Catch Housing, Lot 3 Warner NH

September 14, 2026
Revised September 23, 2026

Re: Site Plan Review Comments
Proposed CATCH 34-Unit Multi-Family Development
Tax Map 35, Lot 4-3
9 Route 103 West Warner, New Hampshire

PLAN OF LAND
LOT 3 - ROUTE 103 WEST, WARNER NH,
ASSESSOR'S MAP 35 LOTS 4-3

LAYOUT AND MATERIALS PLAN
CS1001

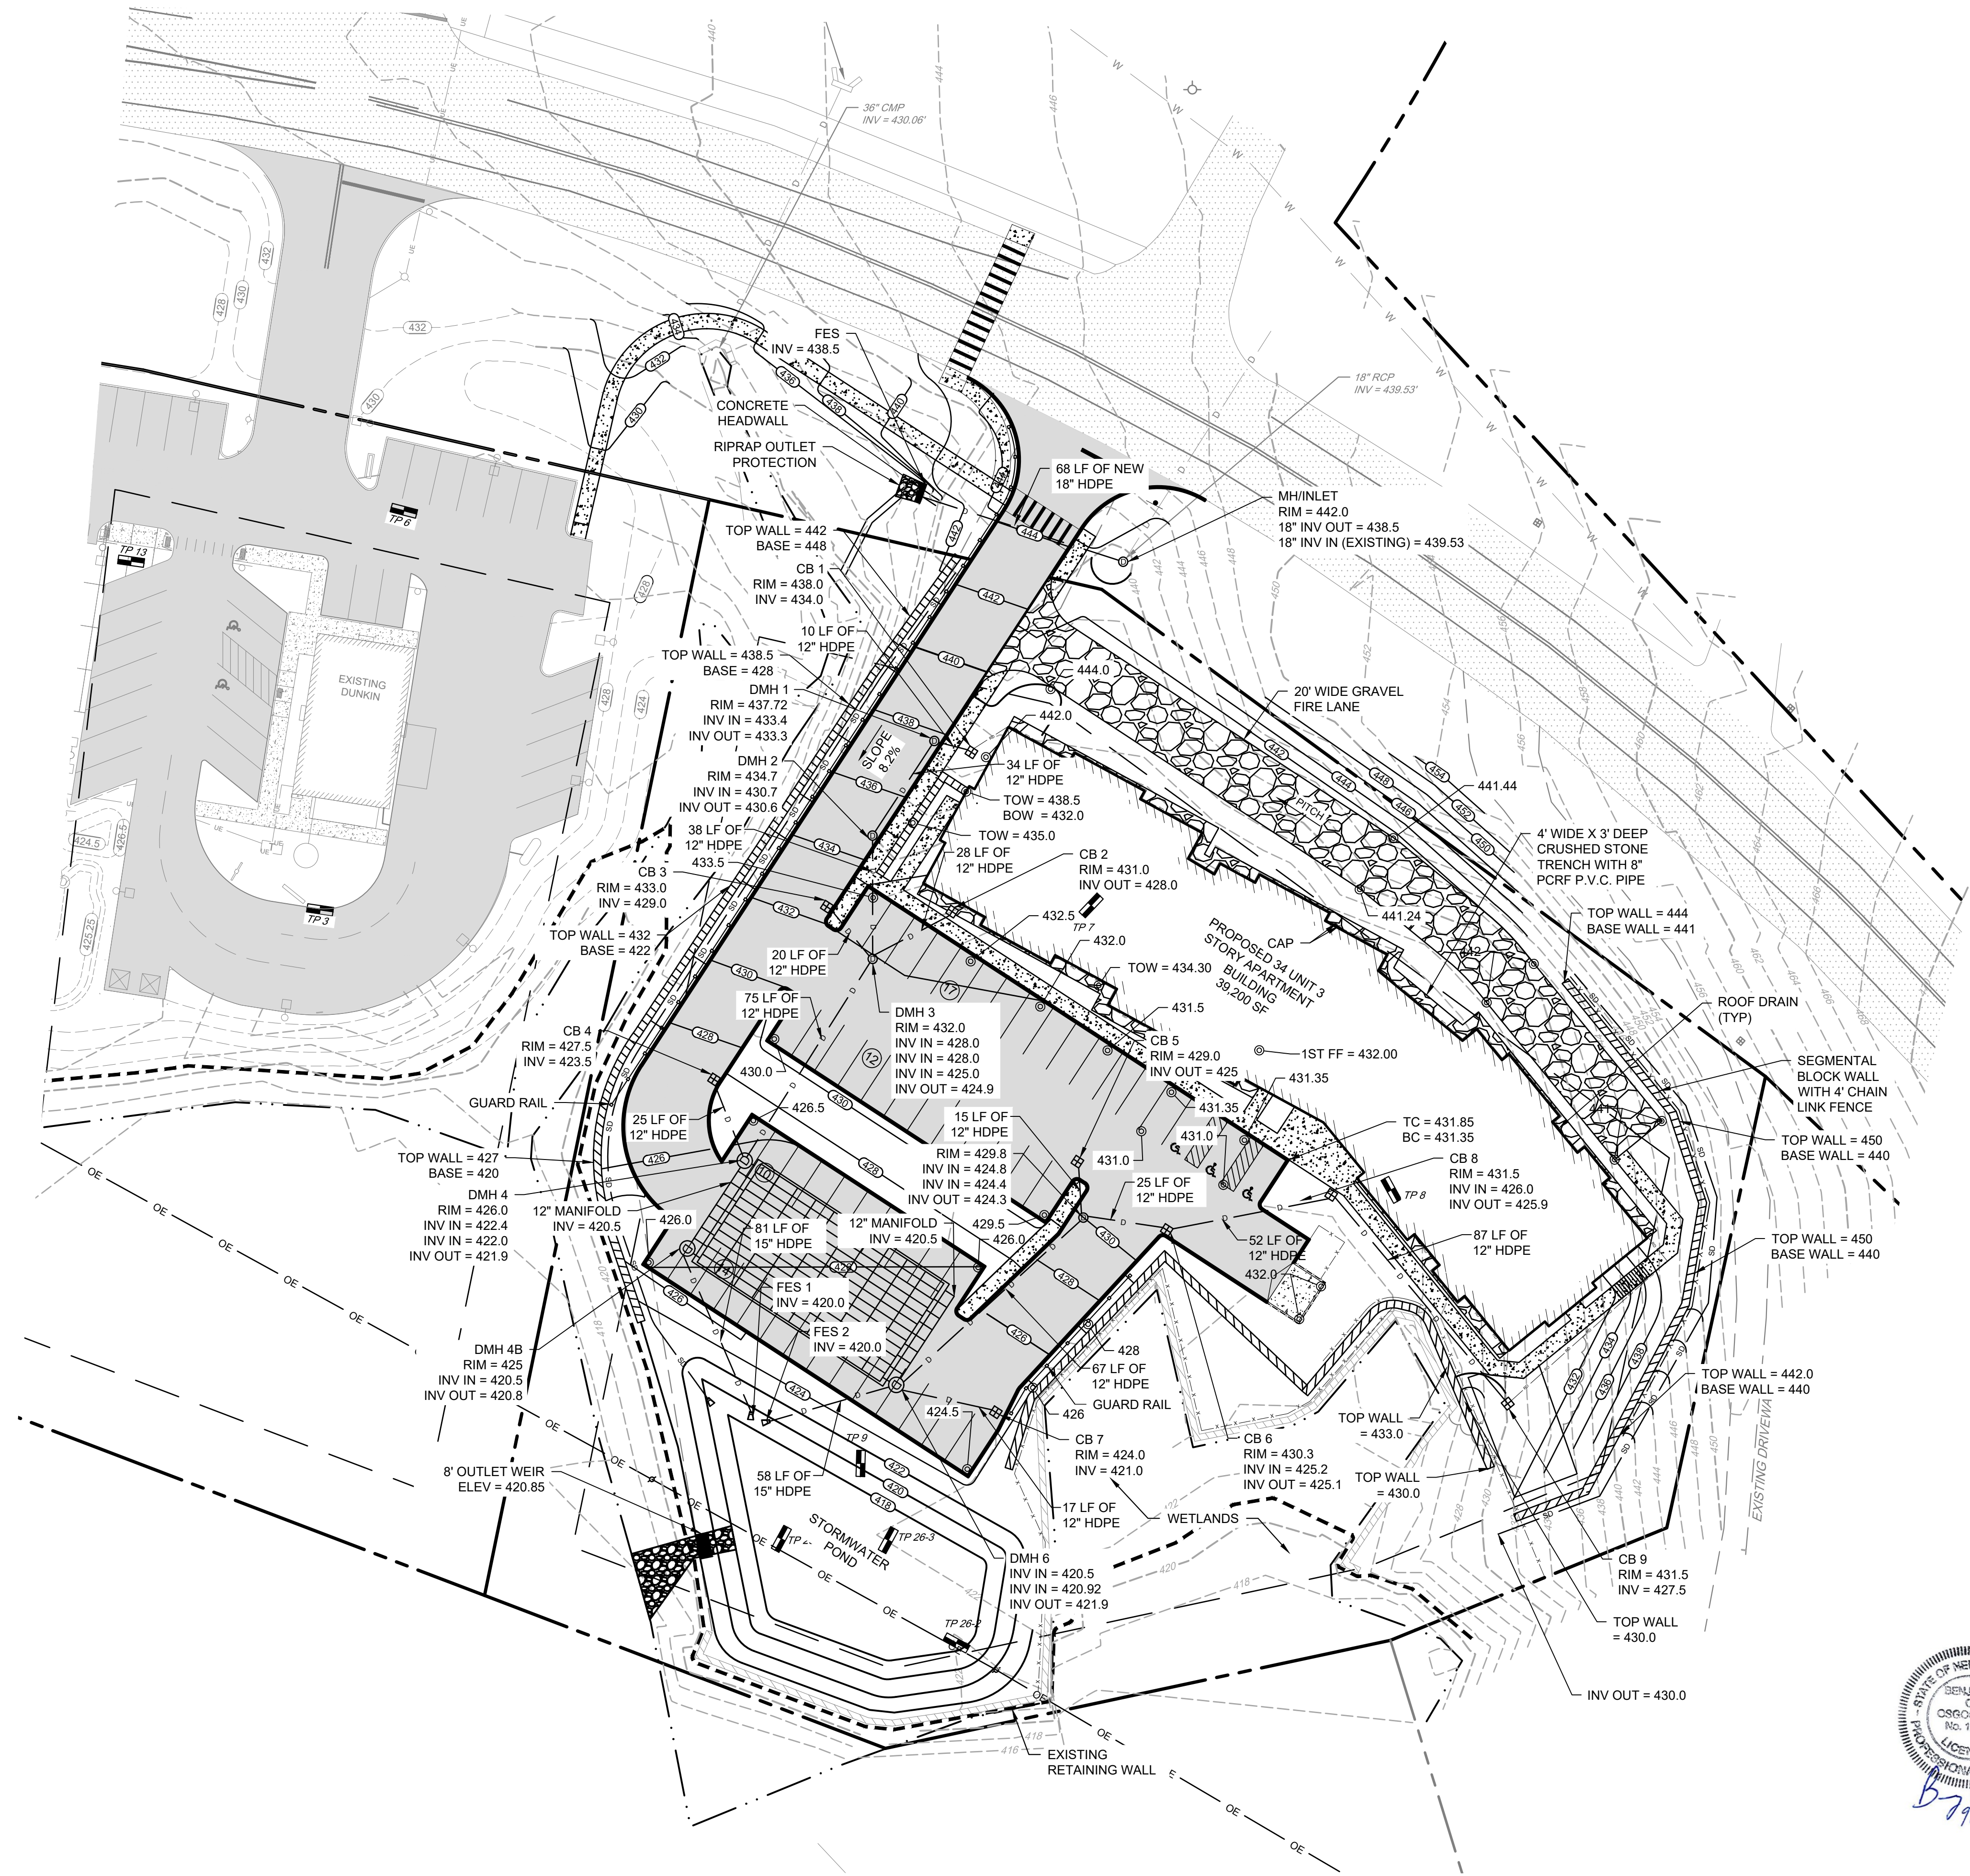
4. Sheets 4 and 5 show buildings on Lot 4-2 as “proposed”, while we understand this building has been constructed. The planning board should confirm with the Applicant that the Site Plans depicts “as-built” features on Lot 4-2.

The features shown are as built features, the proposed building note has been revised.

GRADING AND DRAINAGE PLAN
CS1501

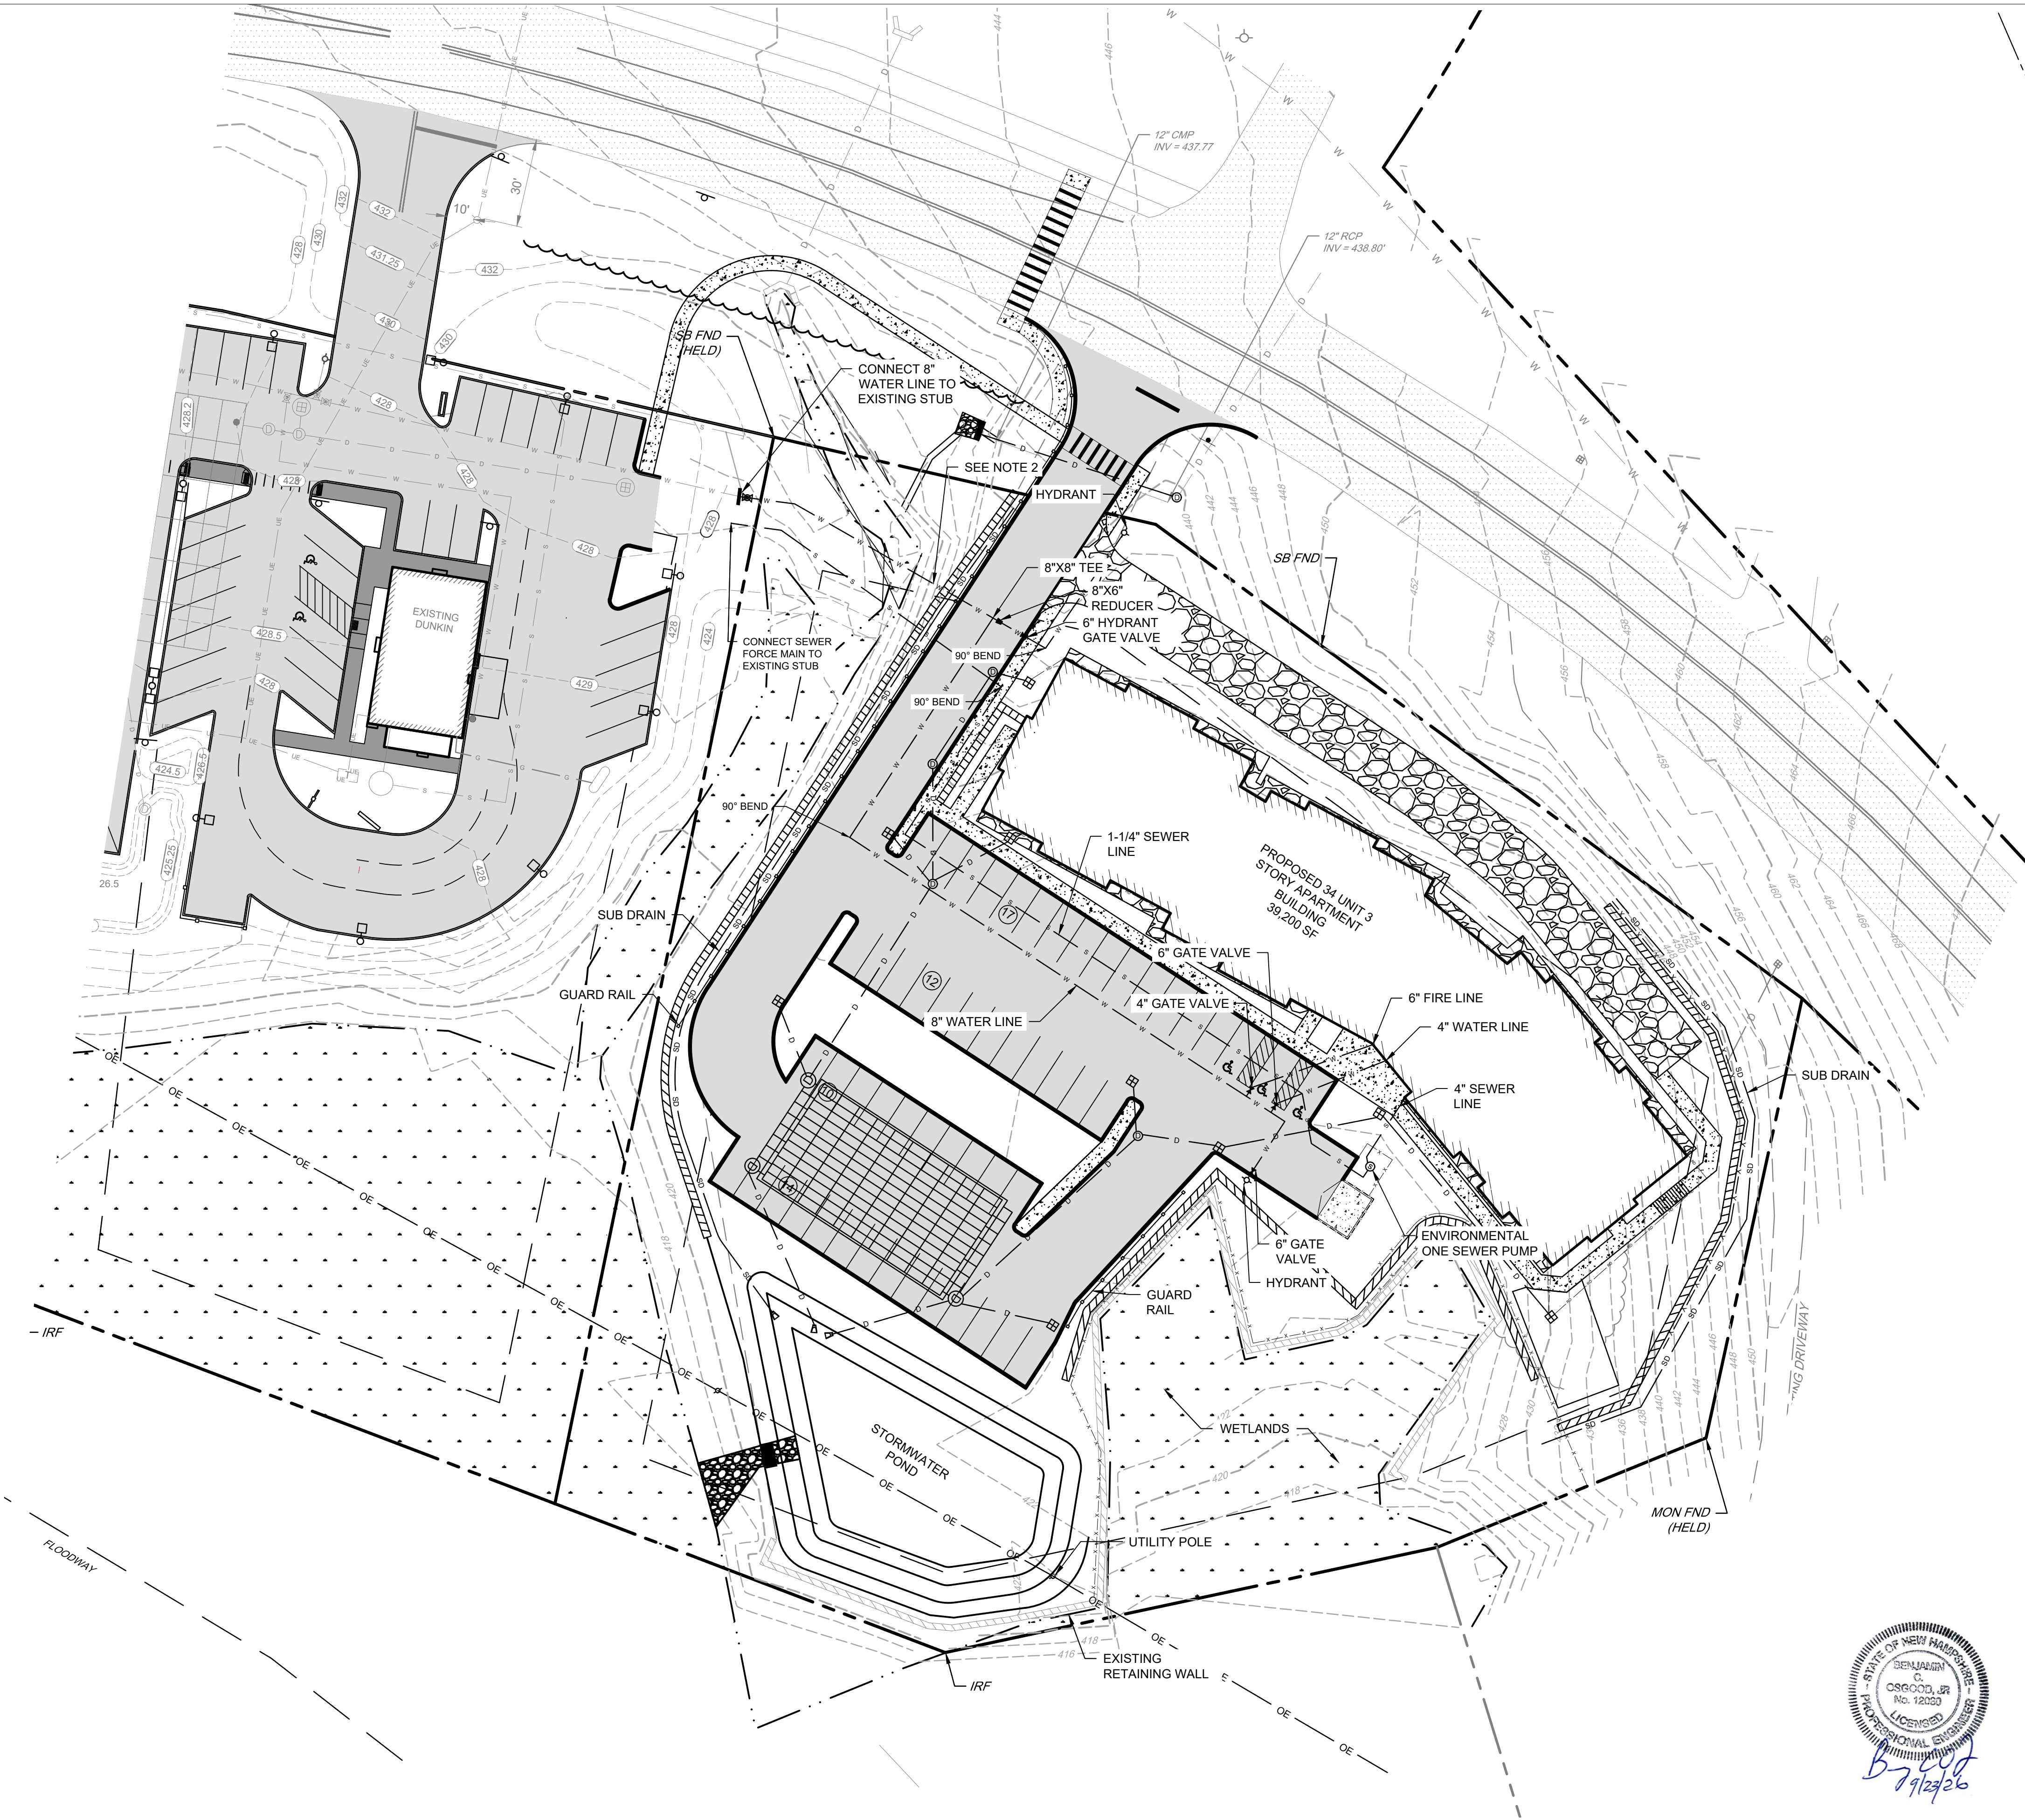
28. Drainage infrastructure is depicted on the Grading and Drainage Plan - CS1501. Drainage appears to be directed from impervious surface toward the proposed catch basins, which is then directed to a stormwater pond.

41. The Grading and Drainage Plan depicts 4-foot-wide trench drains with 8-inch drain age pipe located along the proposed building's drip edge and well as roof drains. The routing of these stormwater conveyances is undefined and not shown on the Site Plans.

Correct, all flow from paved surfaces flows to the detention pond. The roof drains to a buried storage structure which has been added under the parking lot.

The roof drains have been added to the plans. They connect to catch basins that are part of the stormwater system.

35. Detail 1 on Page 12 of 21 depicts an emergency spillway from the stormwater pond at an elevation of 422 feet protected with riprap. The Grading and Drainage Plan - CS1501 does not show an emergency spillway or riprap protection. Please provide a detailed plan depicting an emergency spillway with outfall location and downstream channel protection.

The OCS has been eliminated and replaced with an outlet weir. The weir with the associated spillway have been shown on the plan view and details.
